1955 PITTWATER ROAD, BAYVIEW

S4.55 AMENDED PLANS

DRAWING LIST

Entry Floor Plan

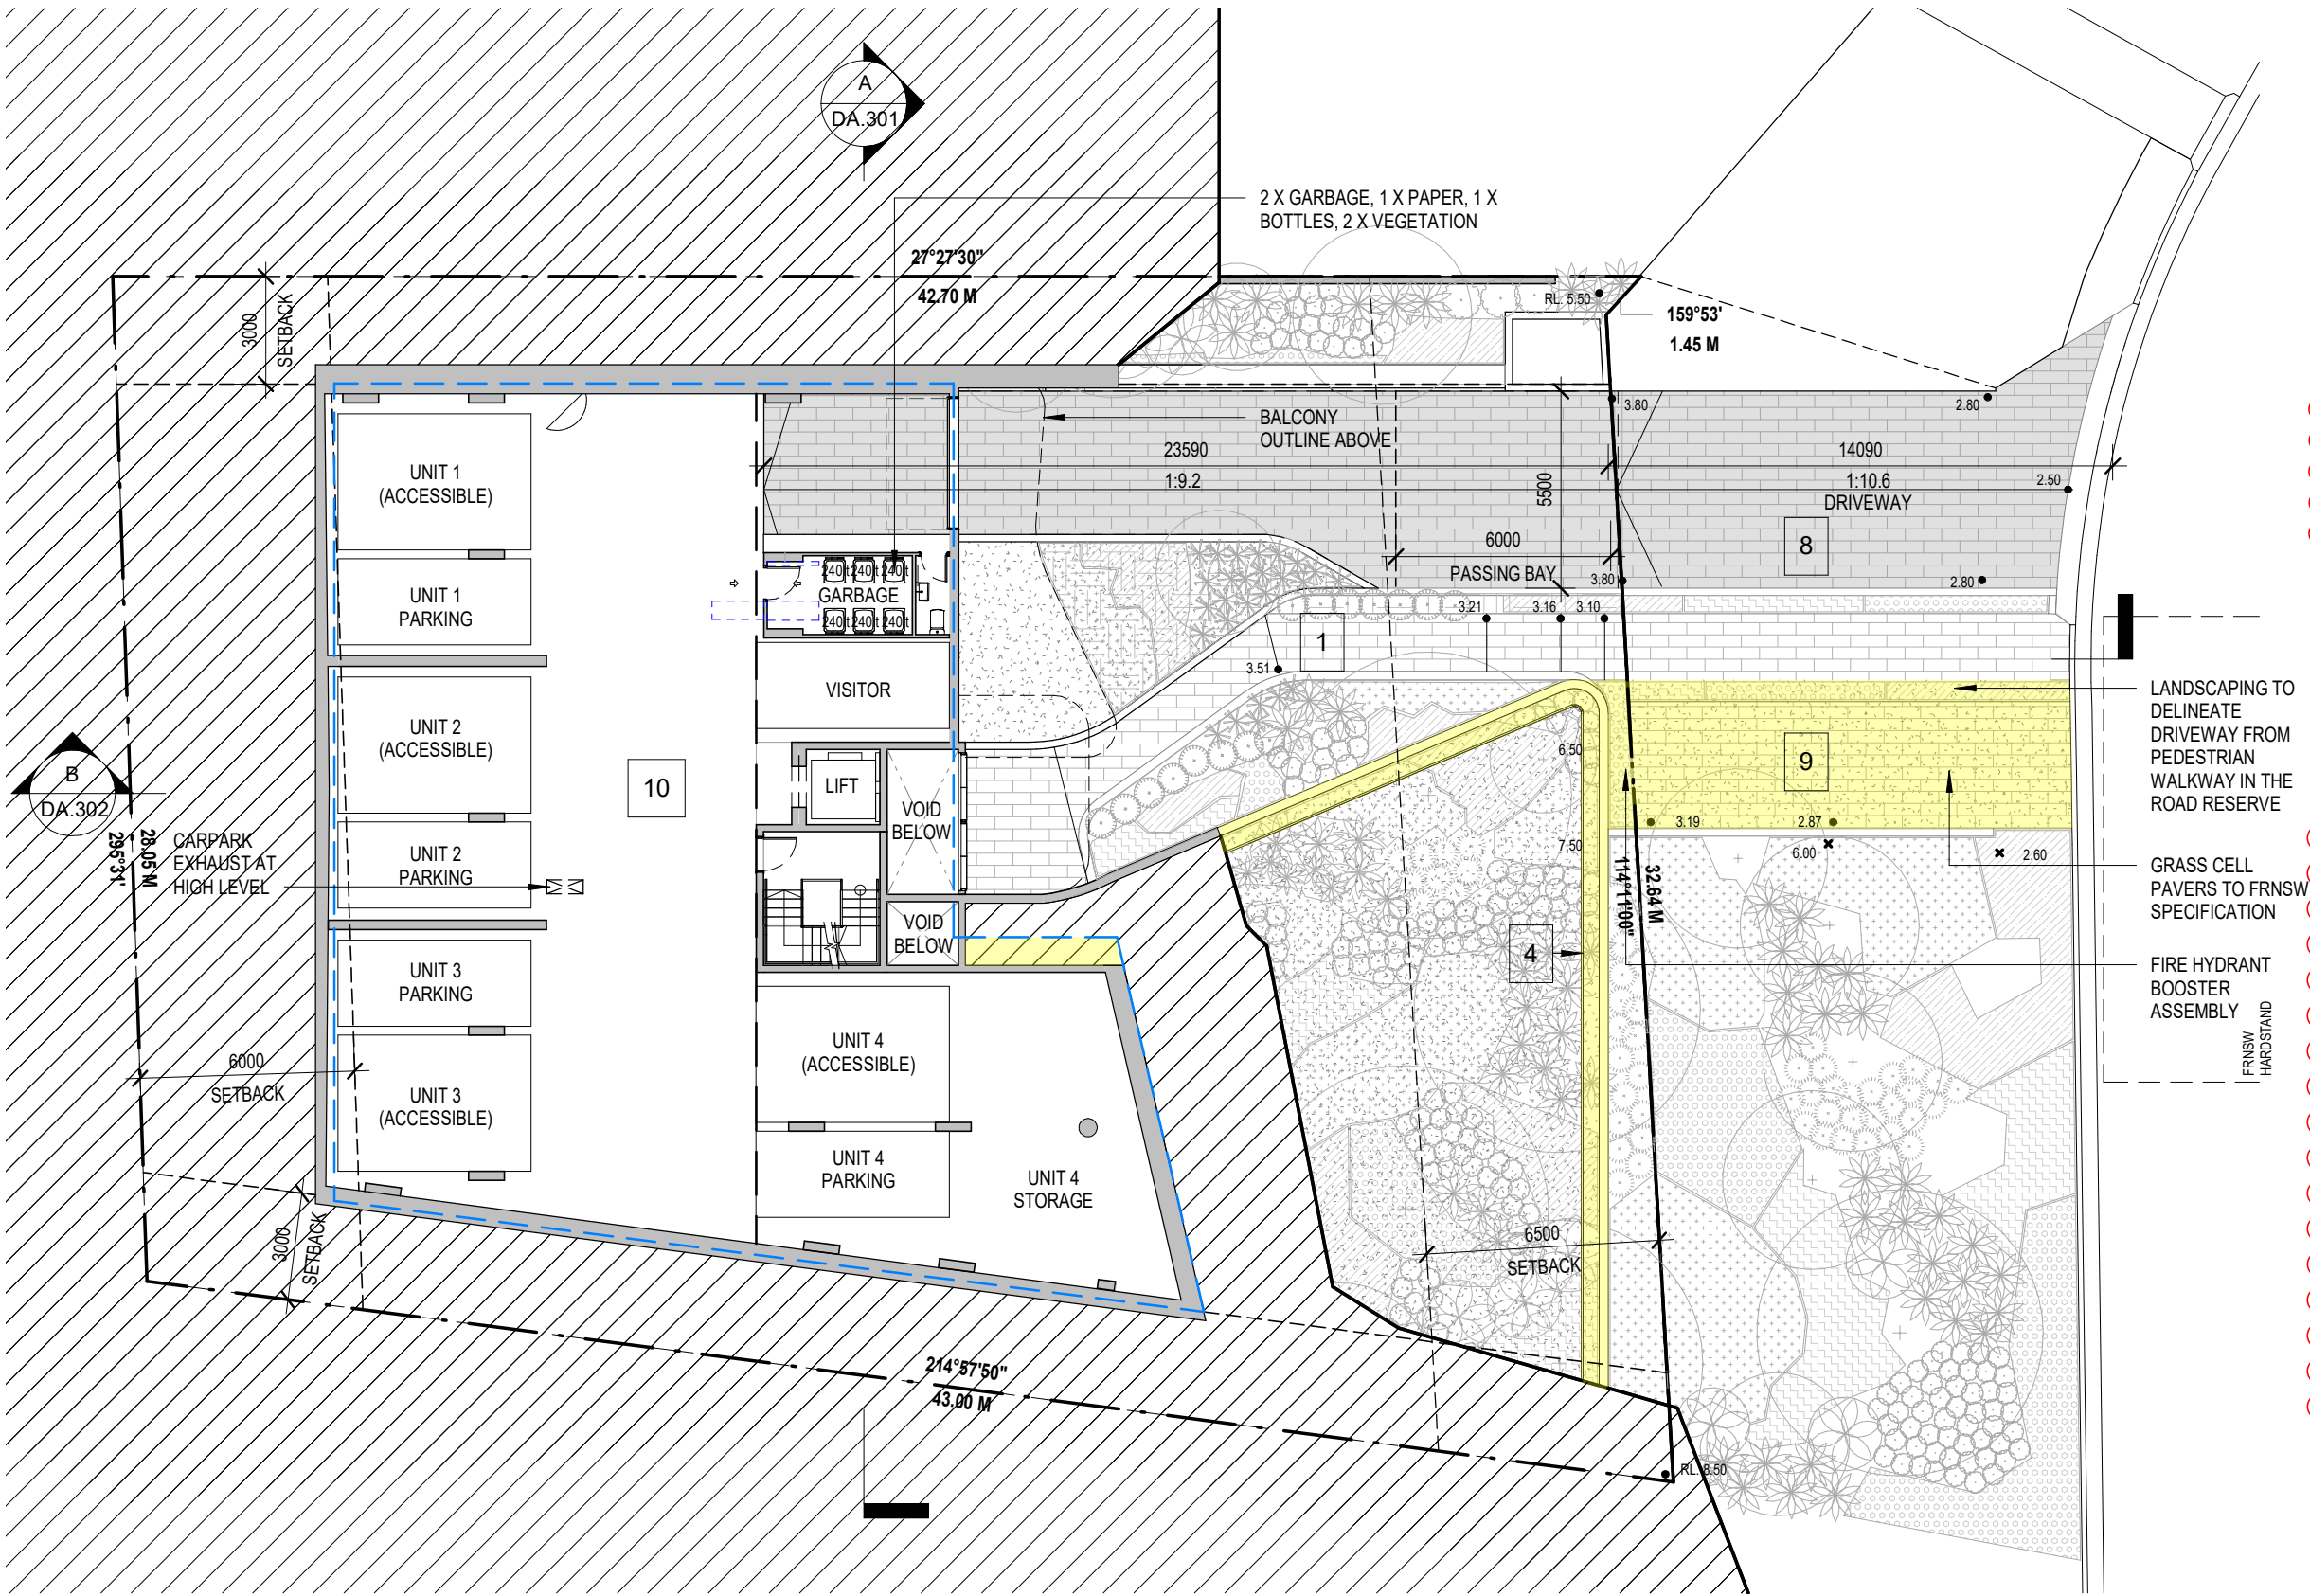
1. **Entry Pedestrian Ramp** - Increased pedestrian ramp width to 1600mm for accessibility
2. **Building Entry** - New awning and vertical louvre screen to increase sense of entry.

Carpark Floor Plan

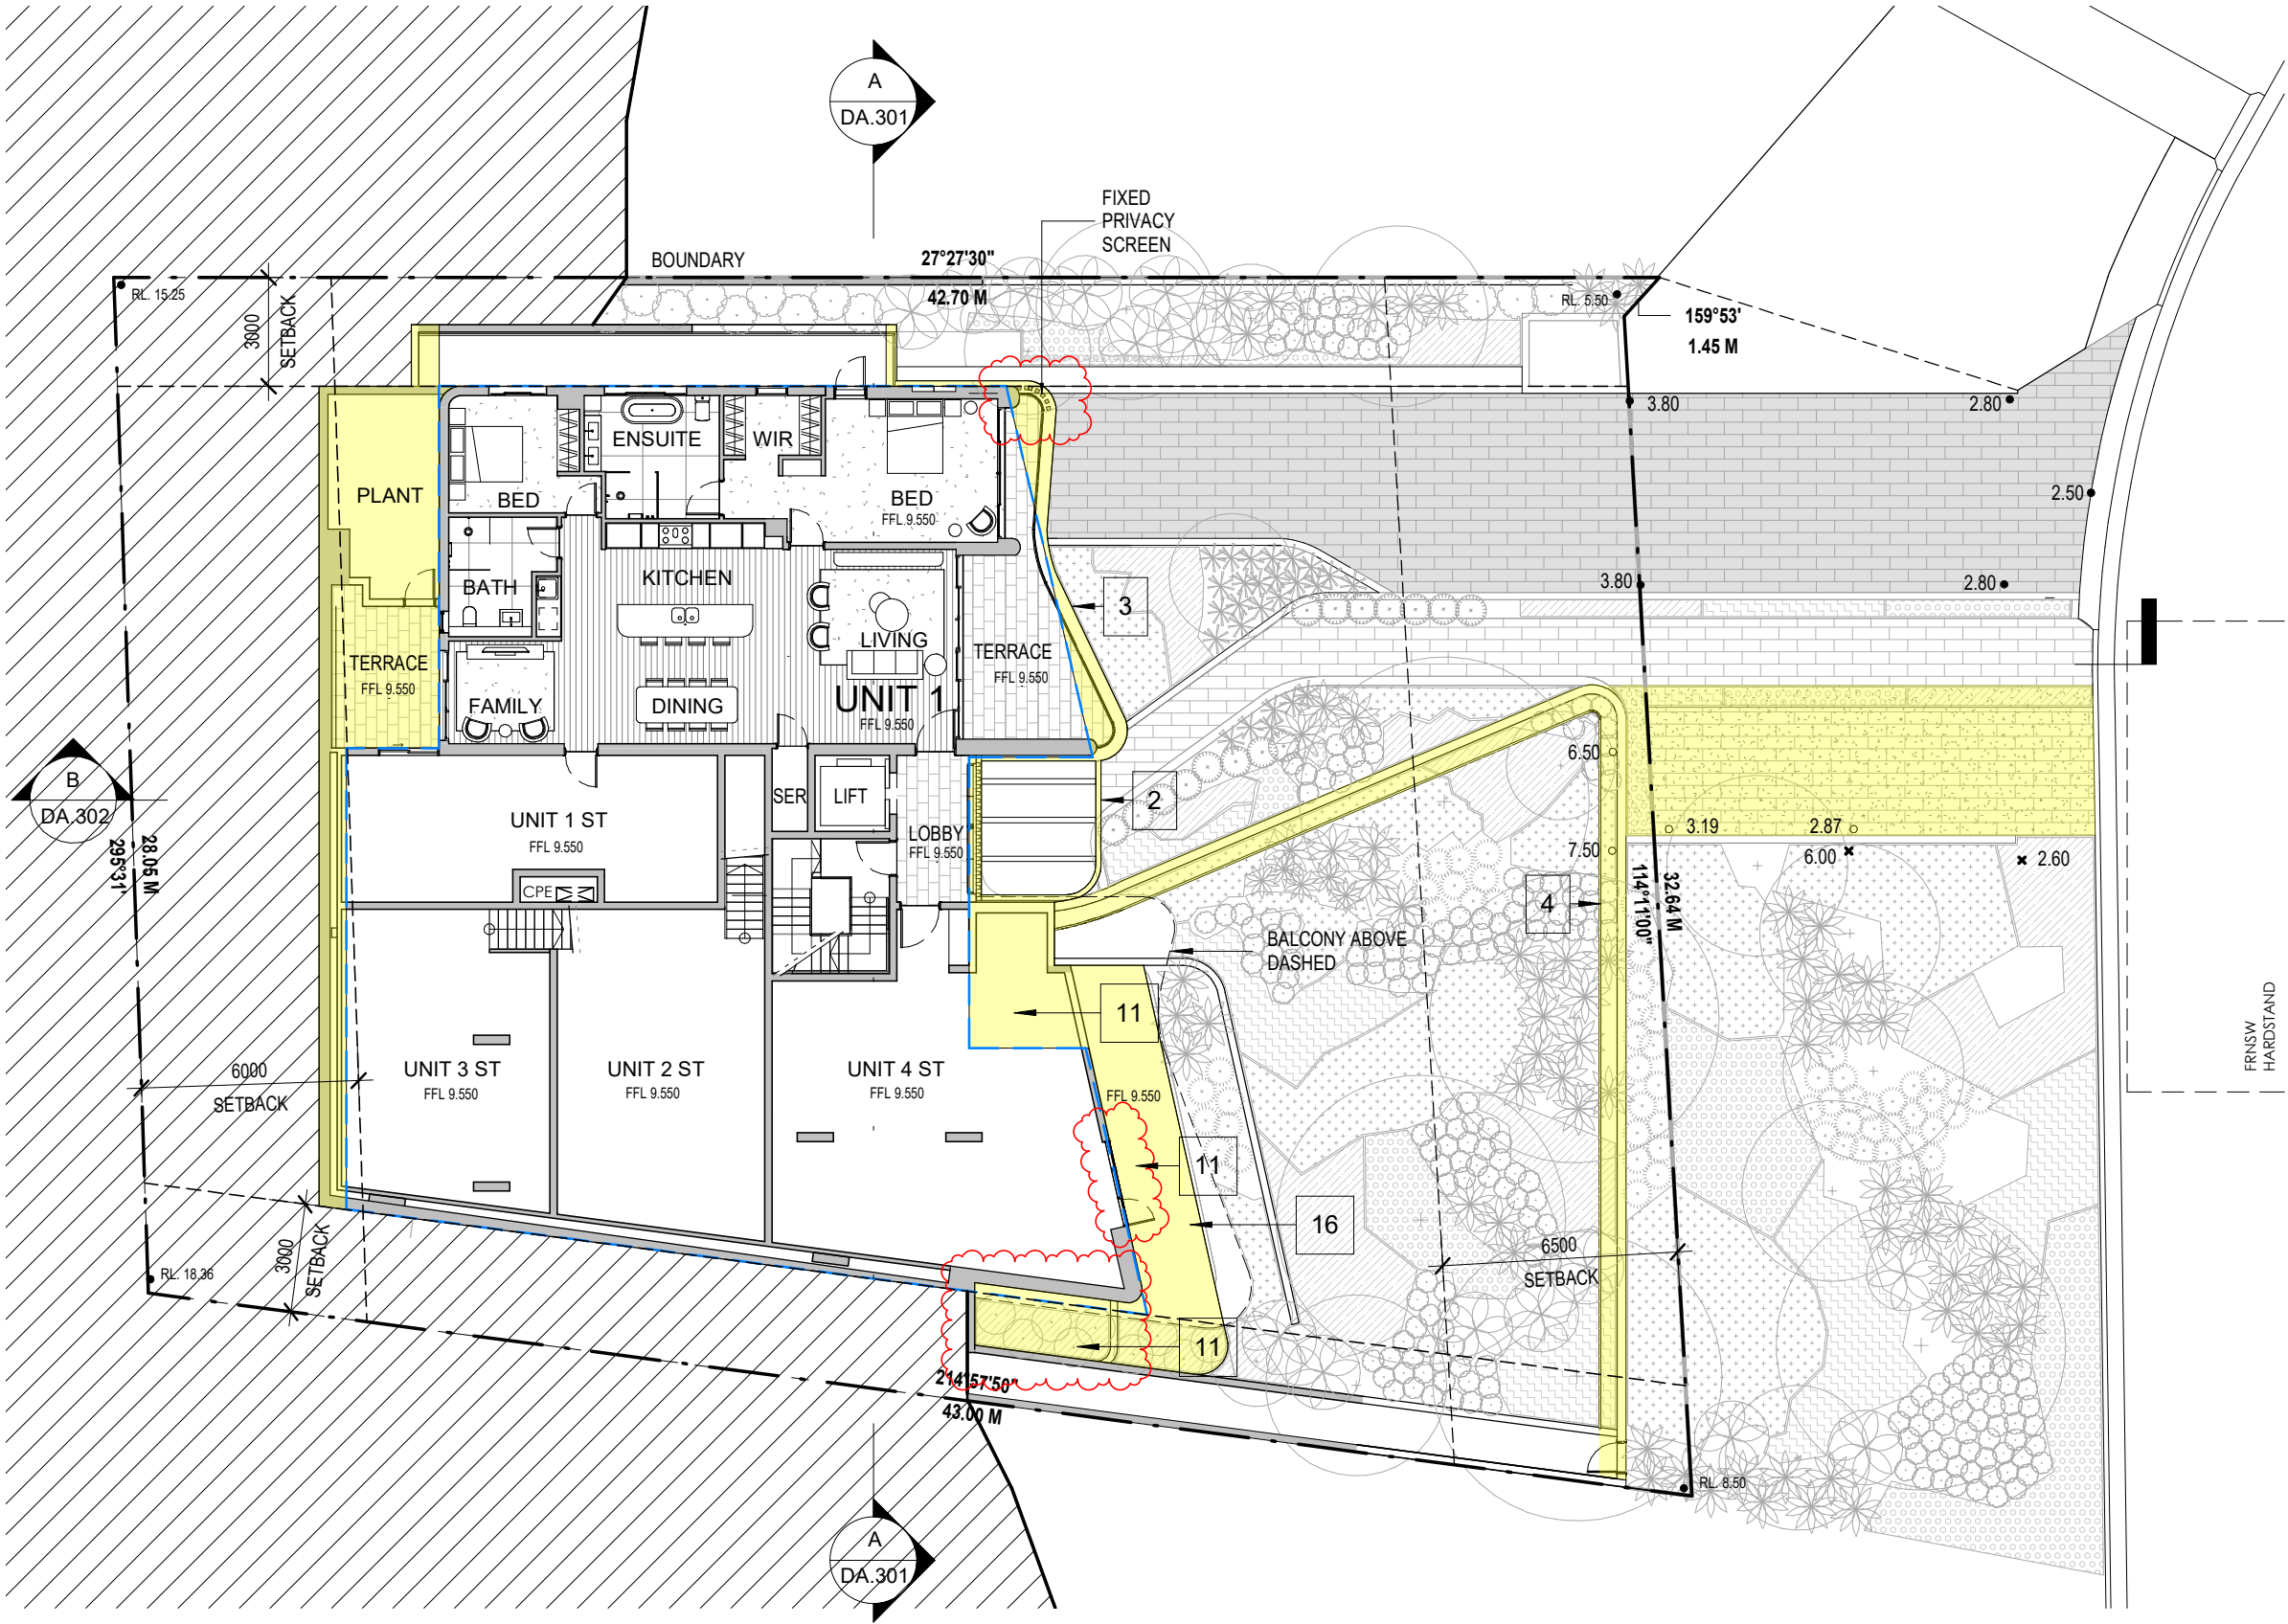
- 9. **FRNSW Requirement** - to provide hardstand & fire hydrant booster assembly , requiring removal of tree T3 (Refer to Arborist Report).
- 10. **Carpark Floor Plan** – Parking re-configuration within approved footprint.

Drawing Title
Lower Ground Floor Plan

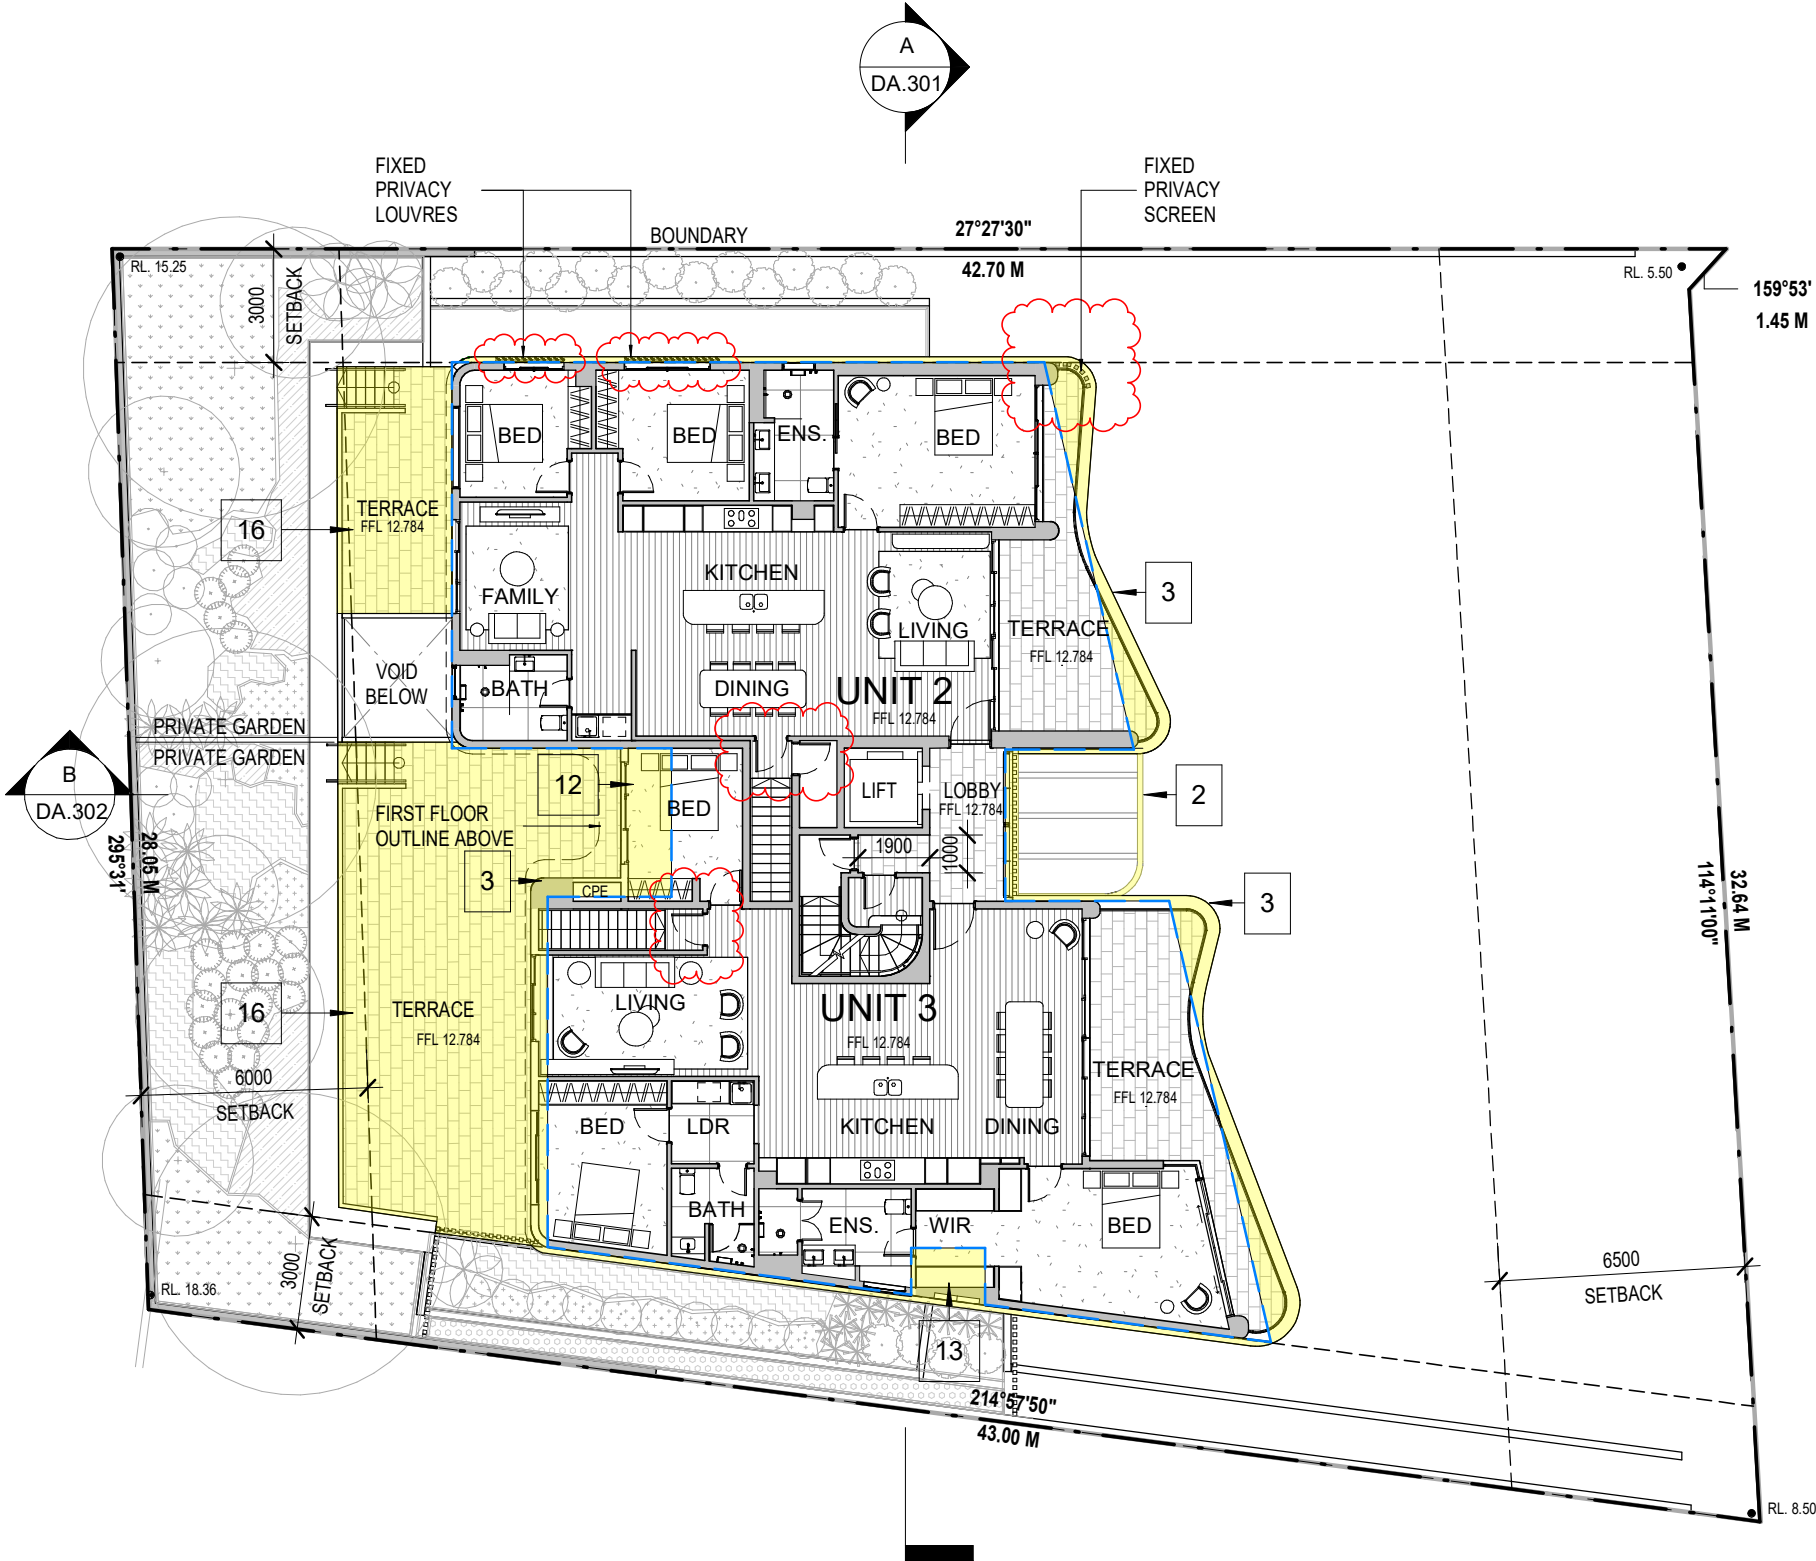
10. Carpark Floor Plan – Parking re-configuration within approved footprint.
11. Lower Ground Floor Plan – Increase in Unit 4 storage area to accentuate recess and alignment between the two modulated built forms. Louvred door and panels for maintenance and ventilation. New landscaped terrace to integrate with cascading balconies above and overall building aesthetics.
12. Unit layouts - Internal reconfiguration and increase in unit size for improved amenity.
13. Elevations - Removal of wall break in east elevation of Units 3 and 4. Revised façade and window treatments associated with plan amendments
14. Boundary Fence - 1.8m high painted fencing capped and lapped in Dulux 'Winter Fog'
15. Vertical Screening - Continuation of vertical screening over lift shaft to accentuate recess between the two modulated built forms
16. Proposed Terrace Extension
